NEC® Code-Making Panel 18 First Draft Meeting Agenda

January 18 - 20, 2024

Charleston, SC

JB Cables Outlet (Duplex Receptacle and Charging Cable)

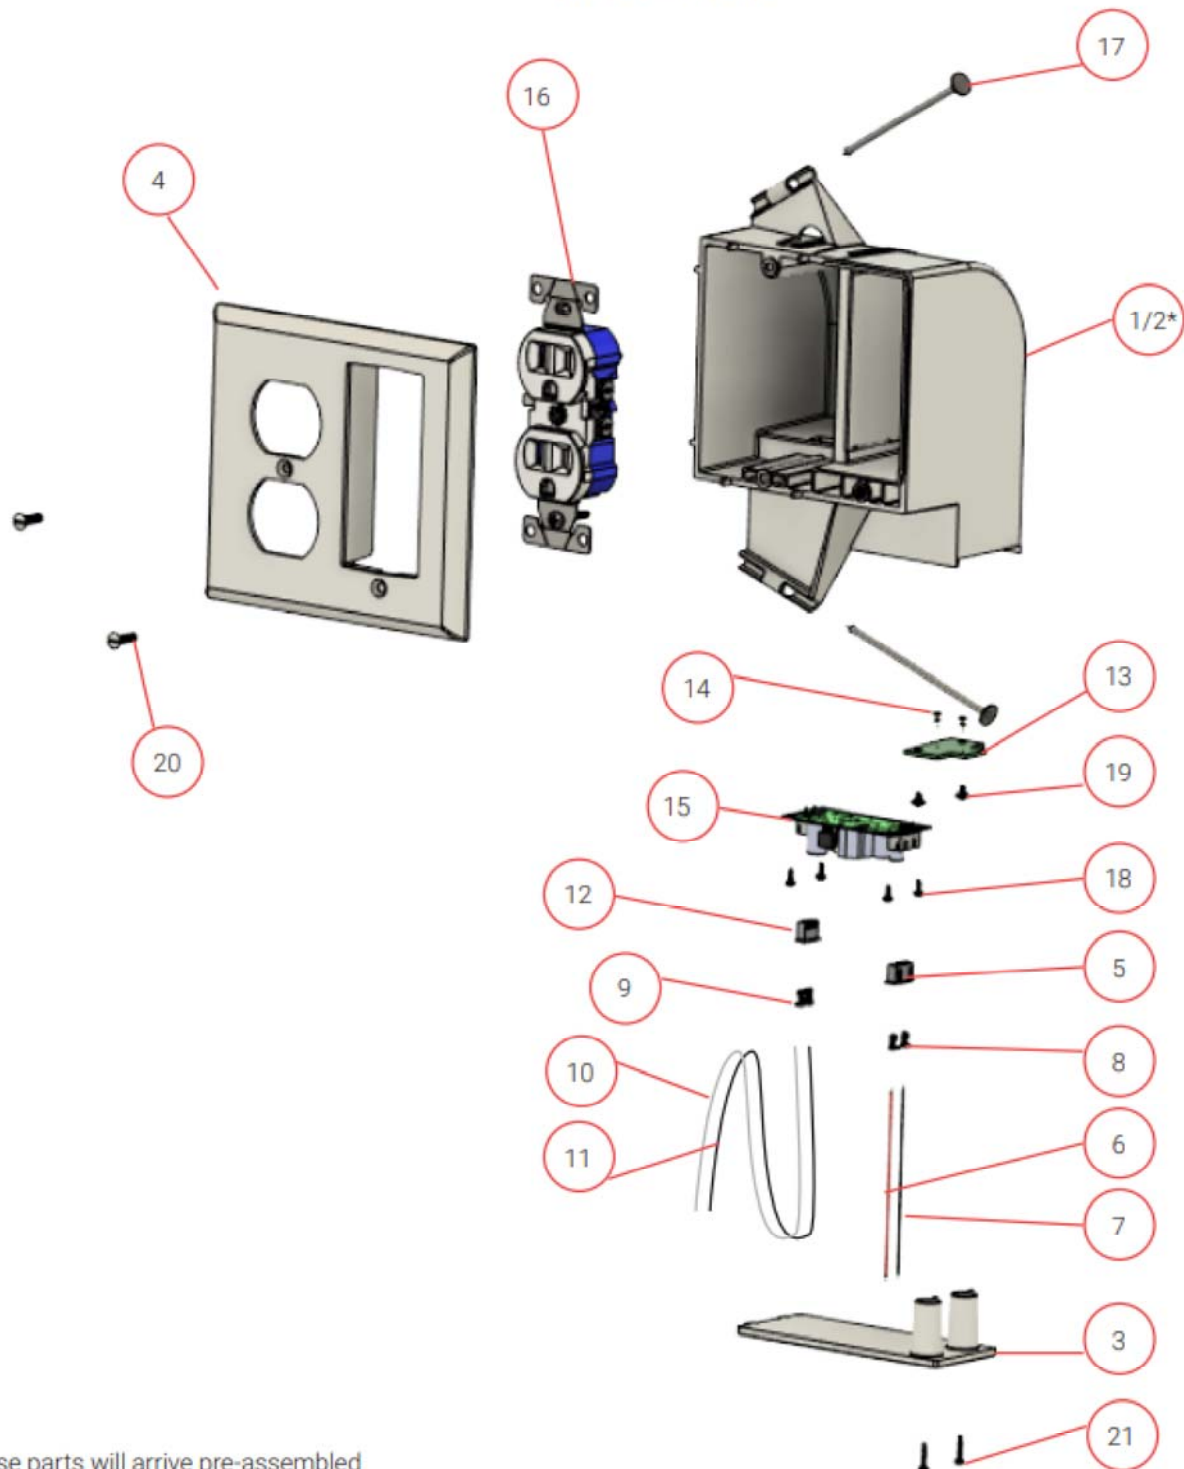
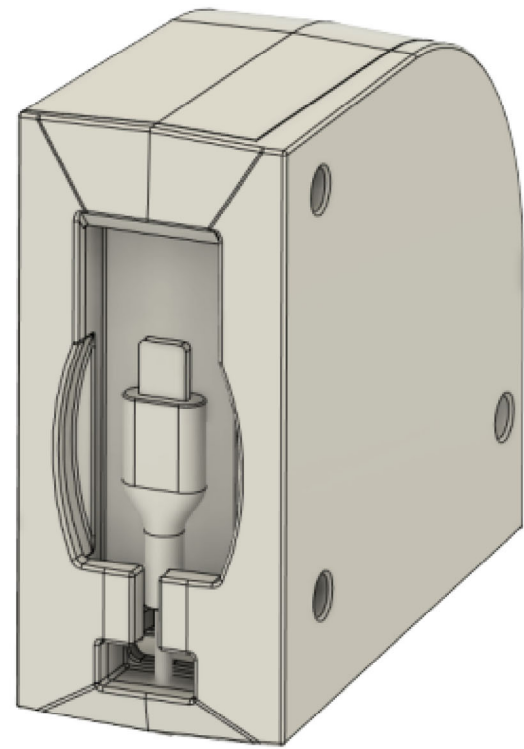
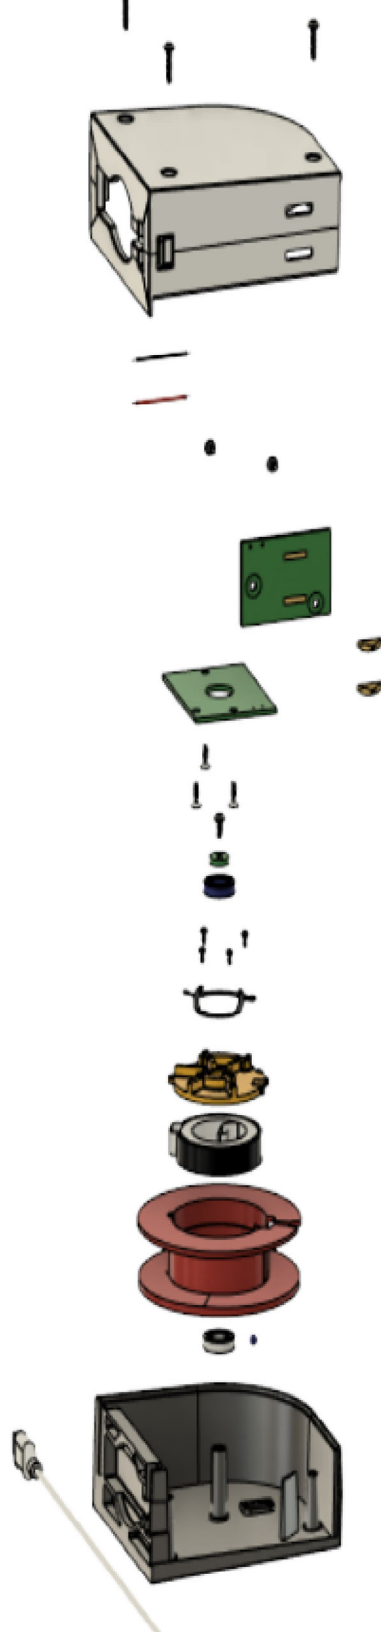
New Work Housing

Old Work Housing

NEW WORK BOX EXPLODED VIEW

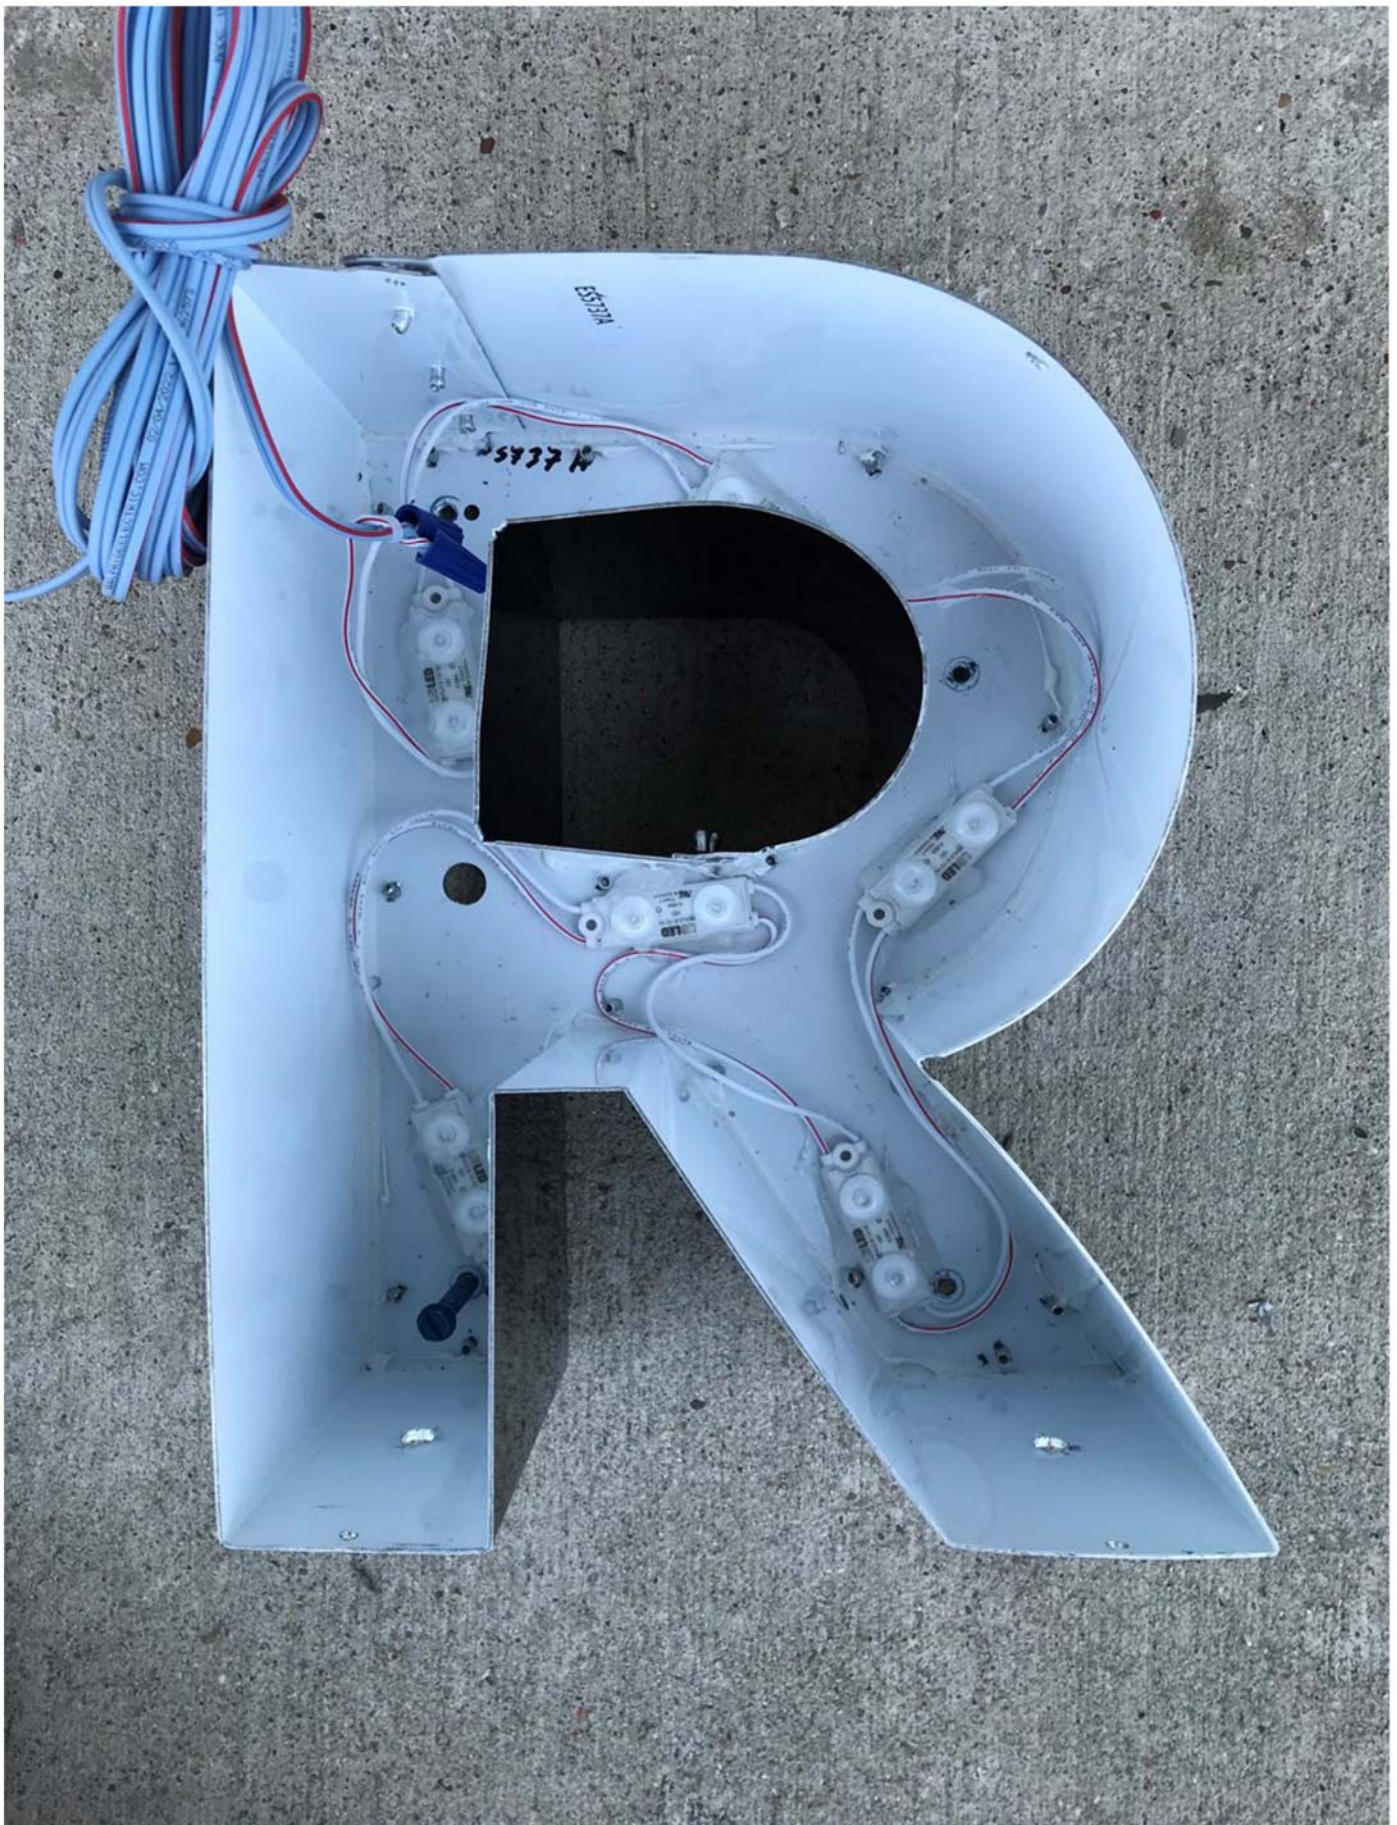
Halo rear illumination with Plexi glass illuminated face. Metal not bonded. 2 wire Class 2 cable installed.

Halo rear illumination with Plexi glass illuminated face. Metal bonded. 3 wire Class 2 cable installed.

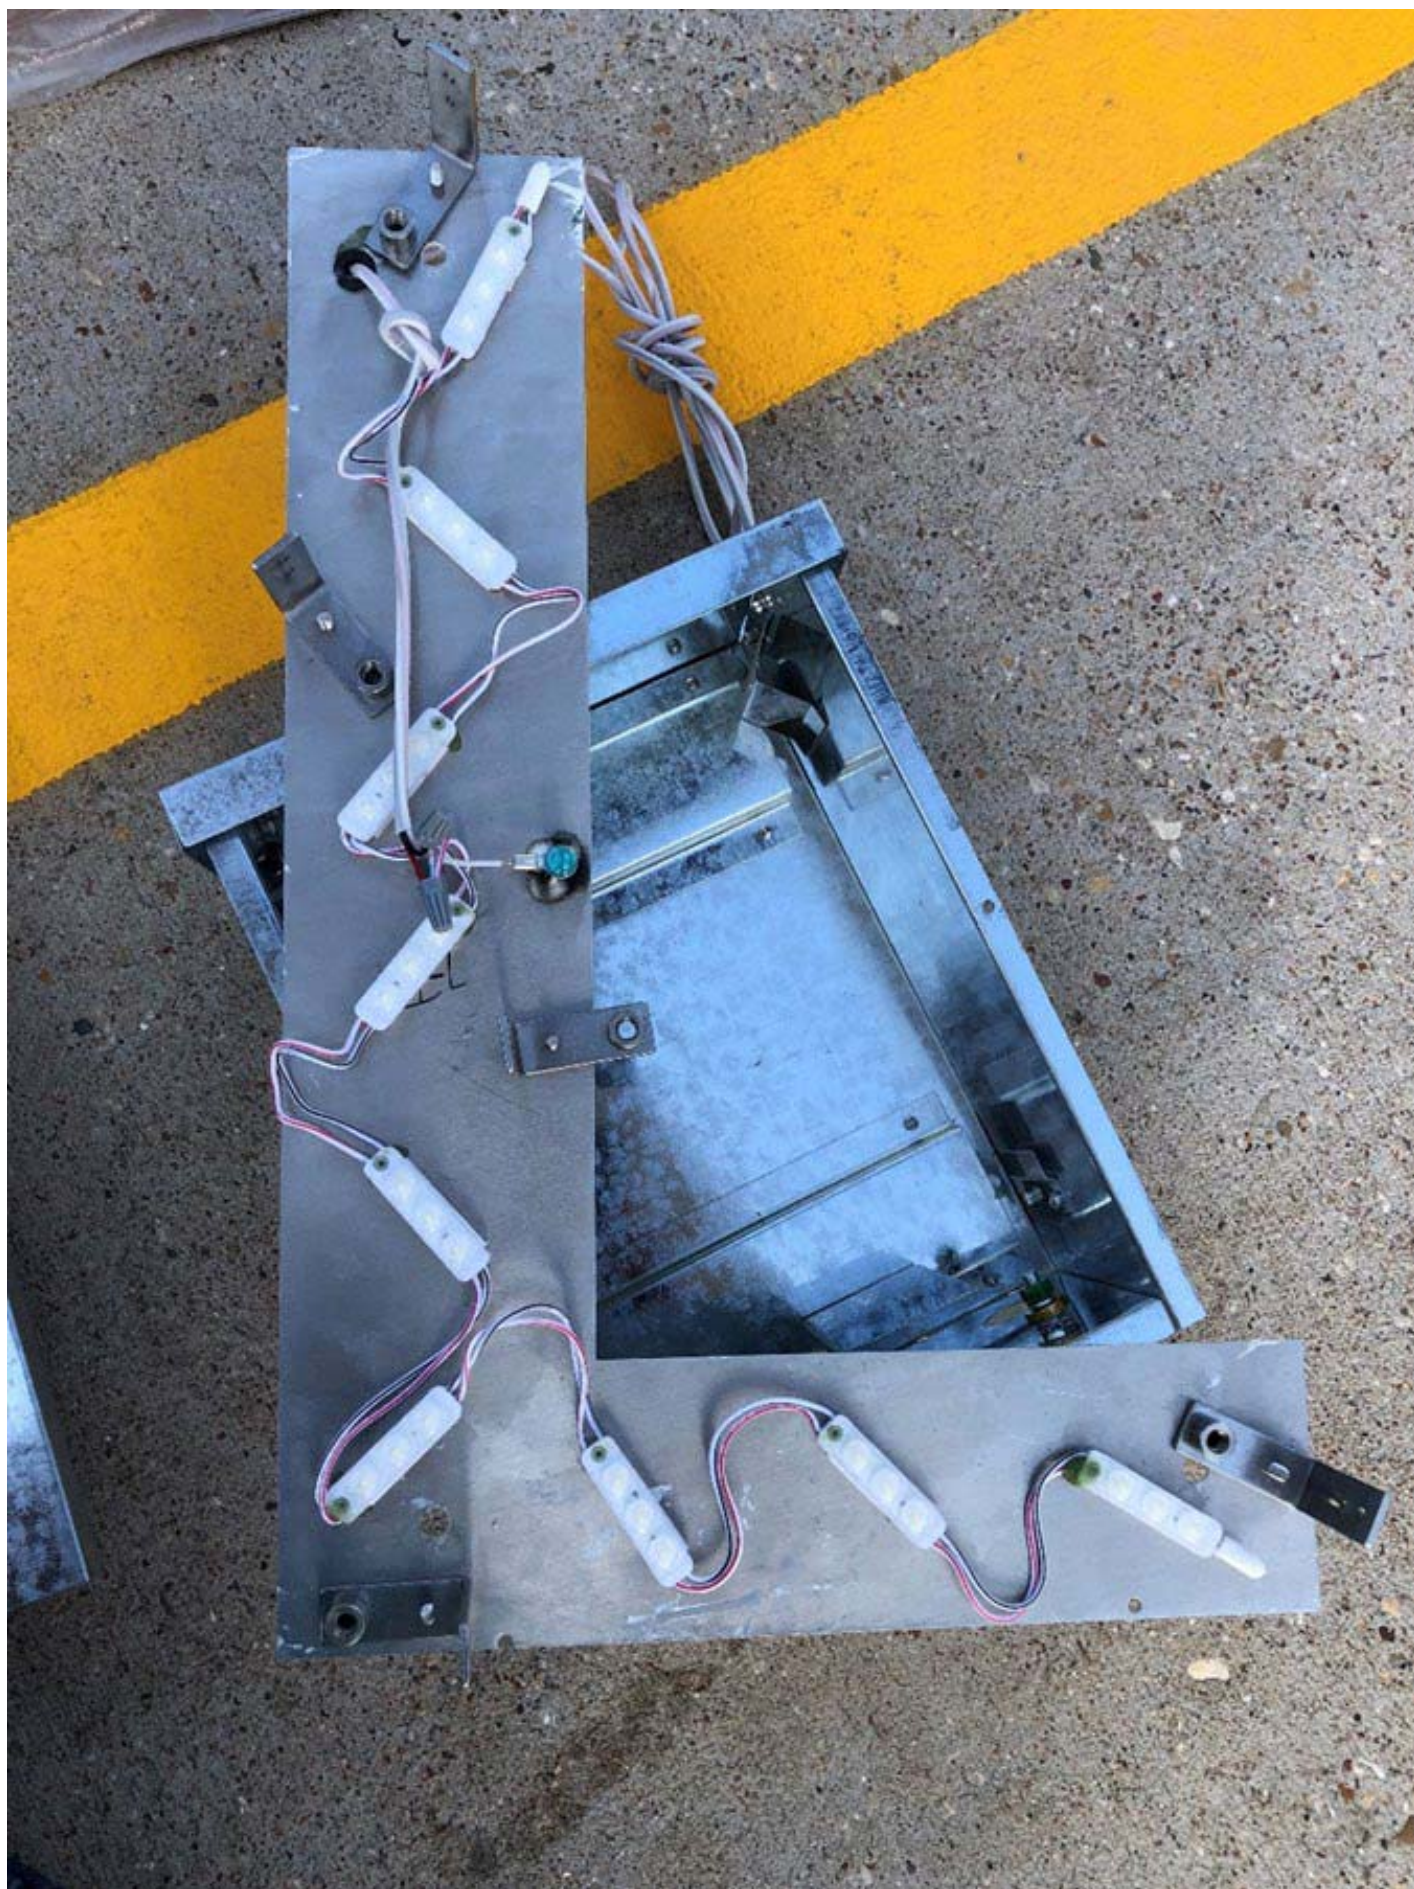
Remote wired Class 2 channel letter metal not bonded. 2 wire Class 2 cable installed.

Remote wired Class 2 channel letter metal bonded. 3 wire Class 2 cable installed.
